**CERTIFICATE OF APPROPRIATENESS**

**Property:** 1332 Cortlandt Street, lot 23, block 168, Houston Heights East Subdivision. The property includes a historic 2,595 square foot, one-story wood frame single-family residence situated on a 6,600 square foot (50' x 130') interior lot.

**Proposal:** Alteration – *Revision*: Replace non-original steel recessed panel front door with a craftsman style 3-lite wood door.

FRONT DOOR

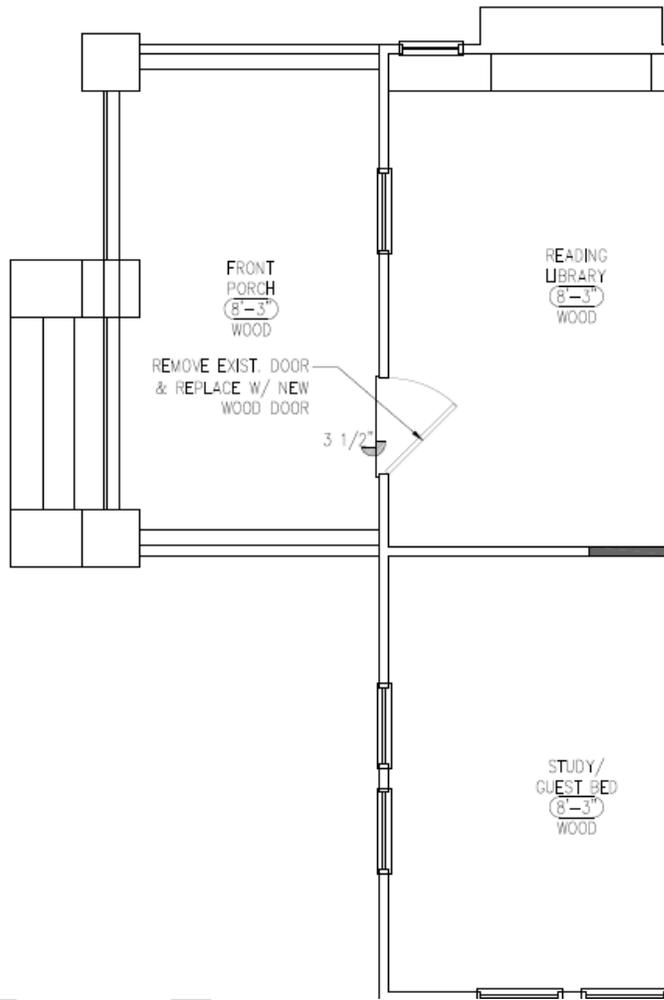
- Existing door opening will not be modified in order to accommodate the new front door.

**Recommendation:** Approval
